Access Compliance Report

Public Rights-of-Way

(Curb Ramps)

Intersection ID: 13404	Main Street: LEXINGTON_AV	Cross Street: E_CARSON_BV	Location: W
ADA ID: 239C288A0C8A	Ramp Type: Perp	Initial Pass/Fail: Fail	Overall Compliance: No
Severity Score: 12.5			
Codes/Mitigation Info/Possible Solution		Field Measurements/Component Compliance

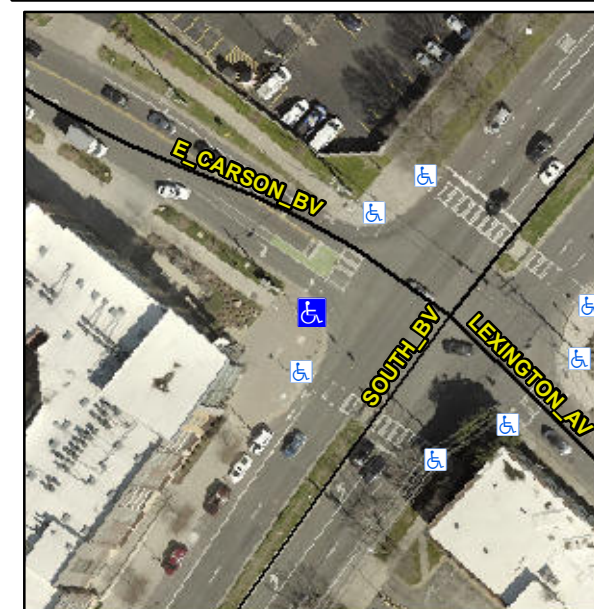
Not Found, R304.2.2

Compliance	Description	Data	Compliance	Description	Data
N/A	Ramp Length (in)	96.0	No	Ramp Slope (%)	9.5
Yes	Ramp Width (in)	48.0	Yes	Ramp XSlope (%)	0.7
N/A	Flare Type LT	N/A	N/A	Flare Type RT	N/A
N/A	Flare Slope LT (%)	N/A	N/A	Flare Slope RT (%)	N/A
N/A	Flare Traversable LT?	N/A	N/A	Flare Traversable RT?	N/A
N/A	Landing Length (in)	N/A	N/A	DWS Provided?	N/A
N/A	Landing Width (in)	N/A	N/A	DWS Contrast?	N/A
N/A	Landing Slope (%)	N/A	N/A	DWS Length (in)	N/A
N/A	Landing X Slope (%)	N/A	N/A	DWS Full Width?	N/A
N/A	Landing Curb? (Y/N)	N/A	N/A	DWS Offset (in)	N/A
N/A	Shared Landing?	N/A			
N/A	Gutter Ponding?	N/A	N/A	Gutter Slope (%)	N/A
N/A	Gutter Lip Ht (in)	N/A	N/A	Gutter X Slope (%)	N/A
N/A	Painted X Walk1?	Yes	N/A	Painted X Walk2?	N/A
	X Walk 1 Direction	To NE		X Walk 2 Direction	N/A
N/A	X Walk 1 Width (in)	114.0	N/A	X Walk 2 Width (in)	N/A
	X Walk 1 Slope (%)	4.3		X Walk 2 Slope (%)	N/A
	X Walk 1 X Slope (%)	0.2		X Walk 2 X Slope (%)	N/A

Remove & Replace Entire Ramp.
